Docket Item # 3
BAR CASE # 2011-0011

BAR Meeting
March 23, 2011

ISSUE: Request for new construction of 21 townhouse units (17 single-family and 4 triplexes), 3 multi-family buildings and park, and waiver of rooftop screening requirement for Phase IV of the James Bland Redevelopment Project

APPLICANT: Alexandria Redevelopment and Housing Authority by Kenneth Wire (McGuire Woods)

Figure 2. Madison Street townhouses strip elevation.

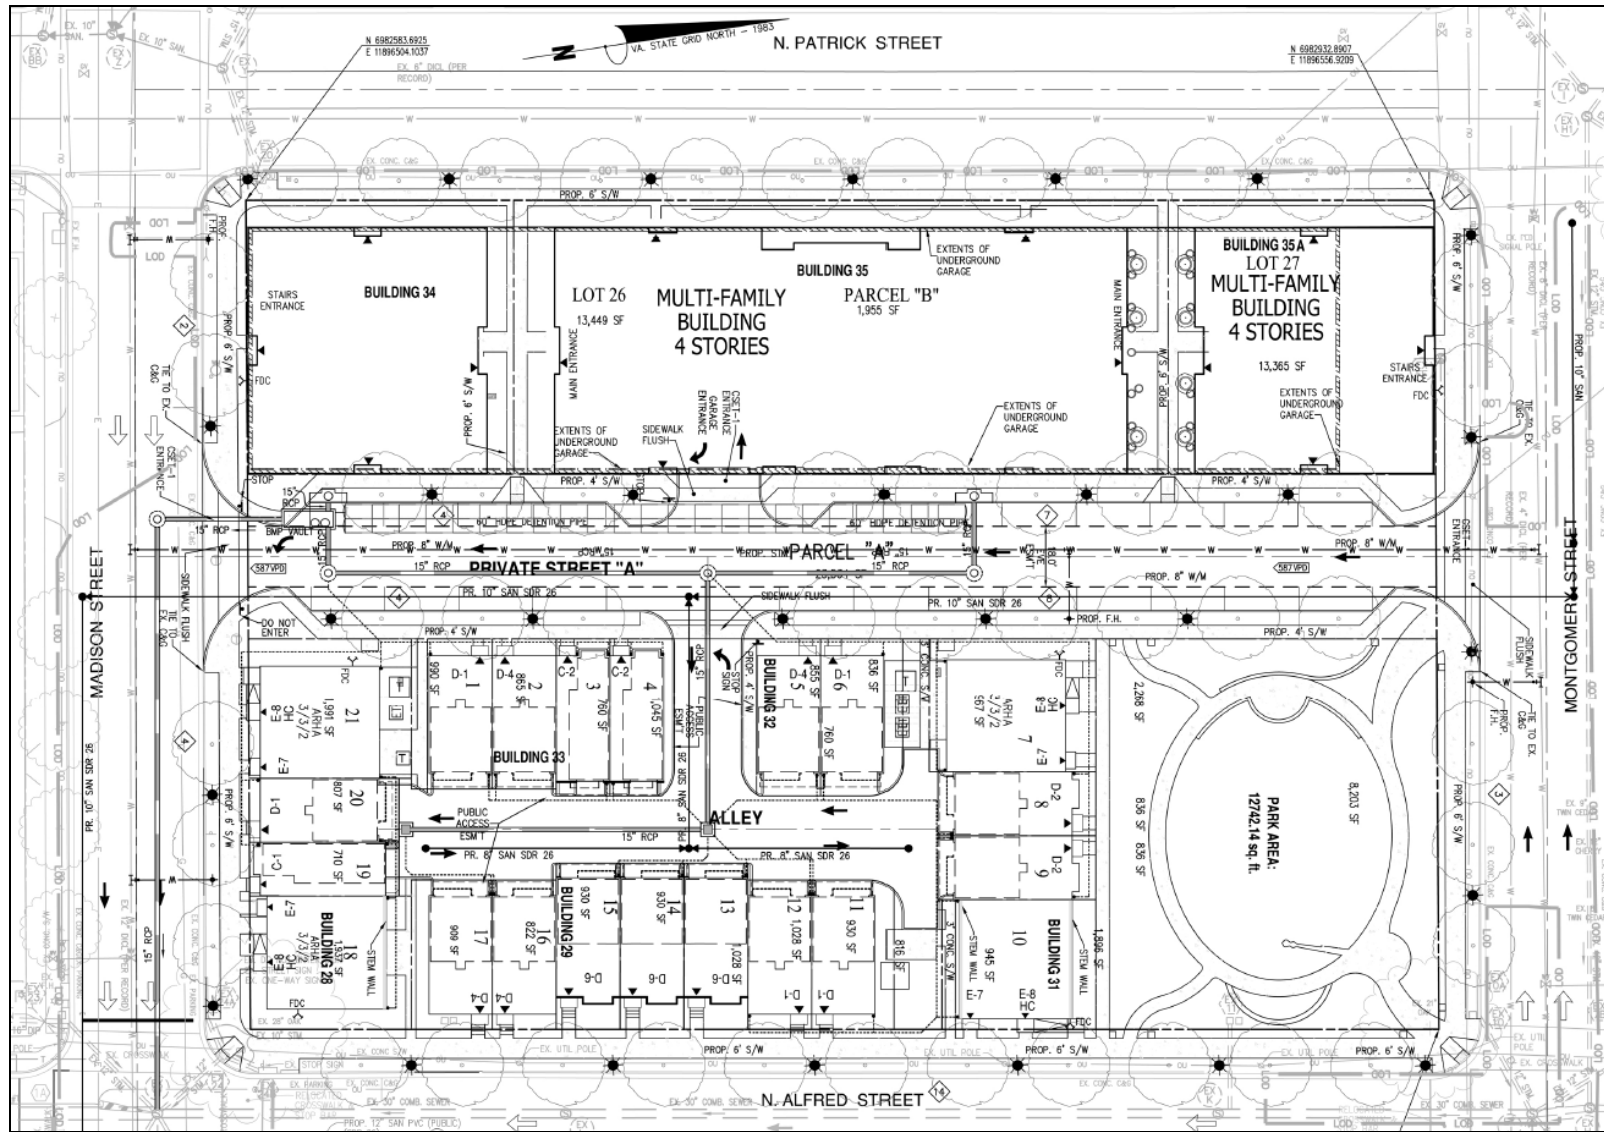
17. That the applicant add windows to the side elevation of the loft level where possible.
18. That the window hoods at the first floor of Lots 18 and 21 on Madison Street be removed.

Figure 5. Private street, northernmost townhouses, strip elevation.

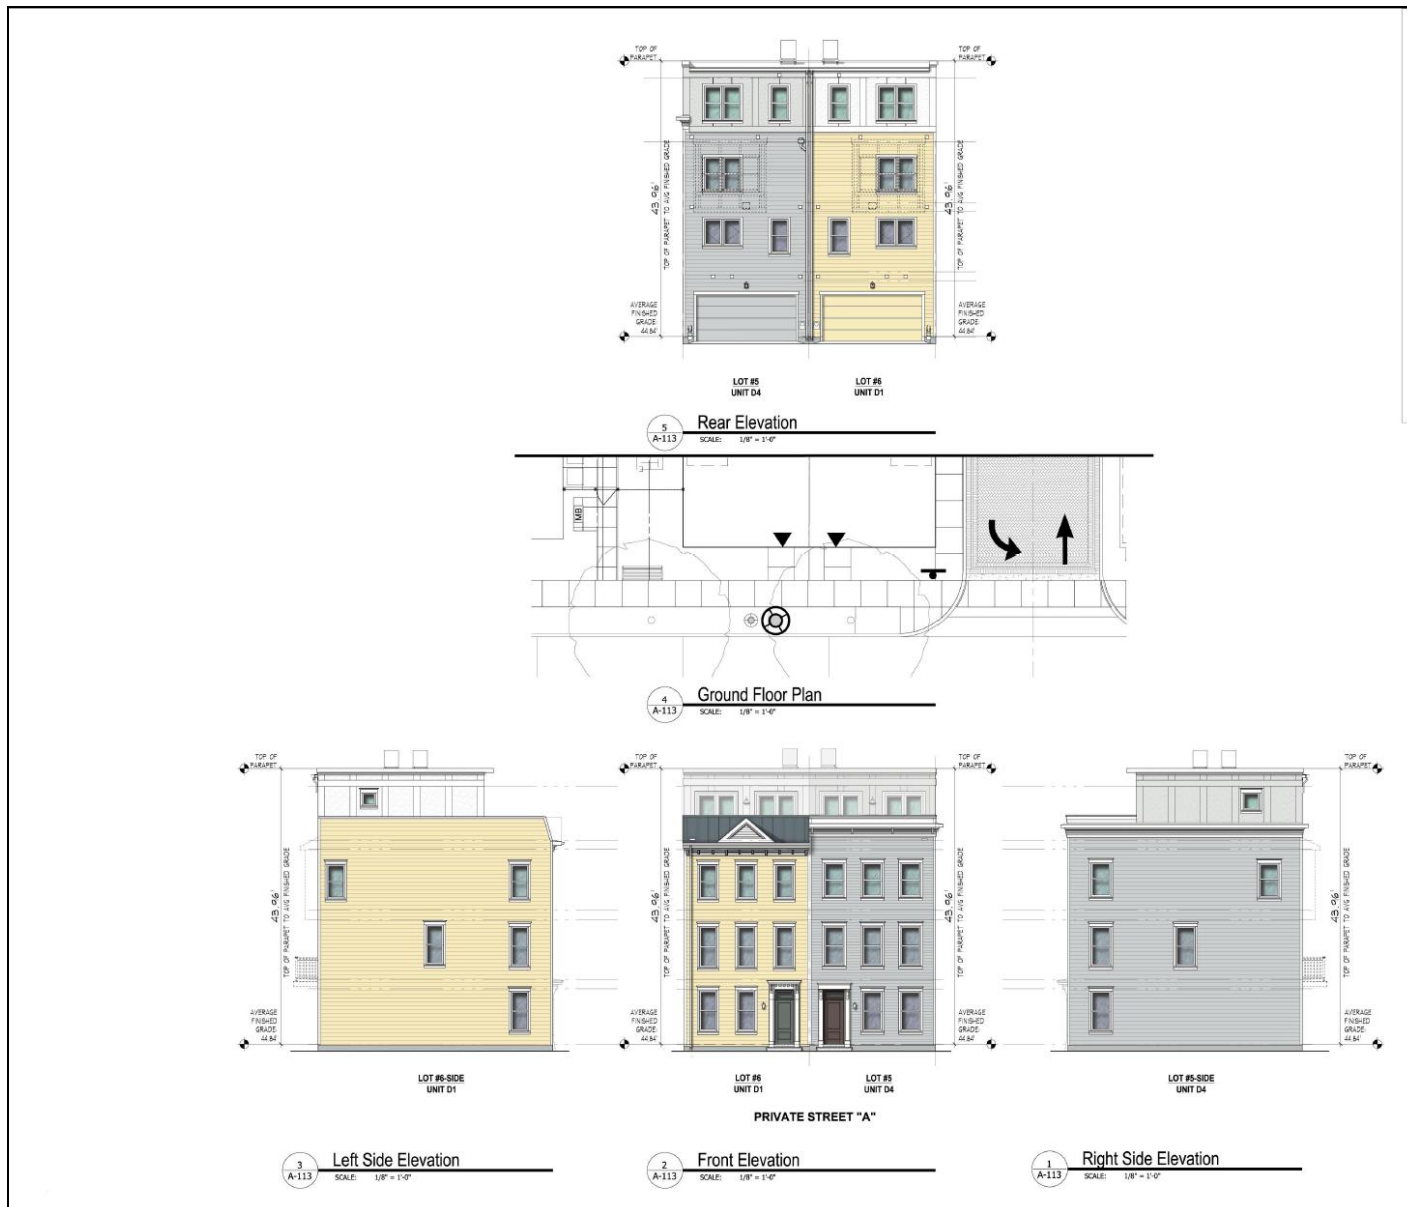
19. That the townhouse units on Lots 5-6 on the private street be a pair of twins.
20. That the applicant restudy the fenestration of the brick townhouse on Lots 3-4 on the private street and consider adding a paired window at the third story.

Figure 10. Center multi-family building with spandrel option.

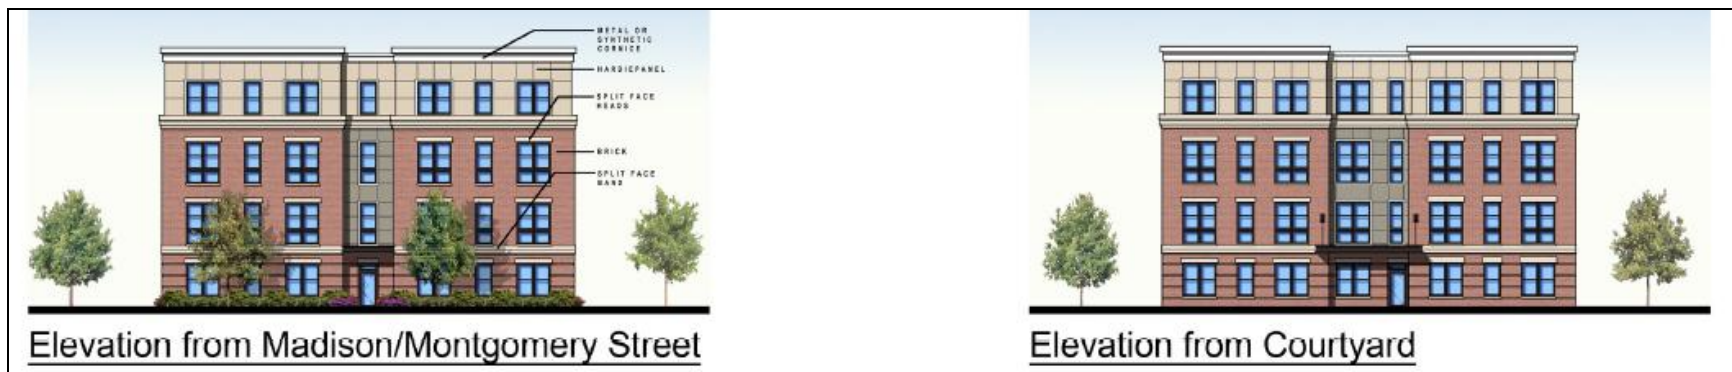
The applicant submitted second option for the multi-family design with a spandrel between the second and third stories on the center building. Staff finds that this contributes to the industrial aesthetic yet detracts somewhat from the clearly articulated punched fenestration. Staff does not have a strong opinion on the spandrel option and finds both schemes to have merit.

Figure 13. Cornice details. Note that the 1.5 foot projecting loft cornice is no longer in use in this project.

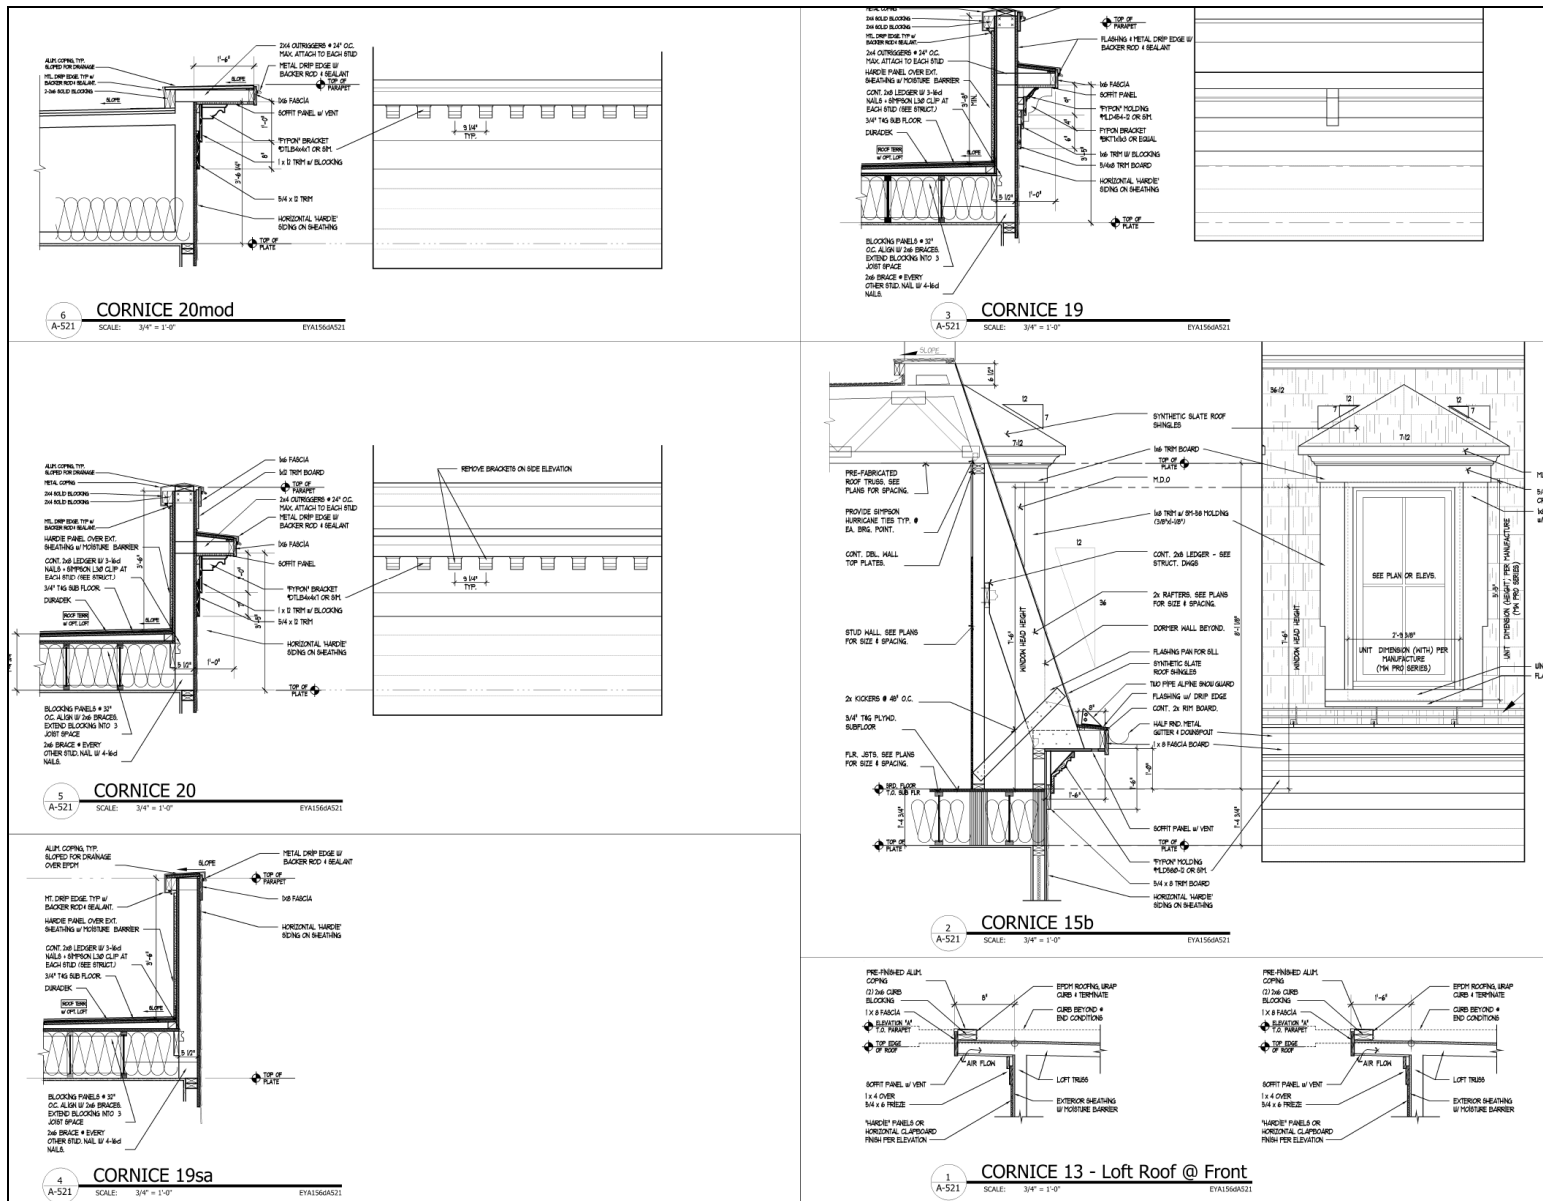
1. Loft cornice – reduce projection (*Reduced to 8” projection*)
2. Entry projection on door hoods (*Will reduce projection on bracketed door hoods*)
3. Foundation treatment (*Will clean up better to reduce mold form and will use a rougher paint to create a more consistent parged finish*)
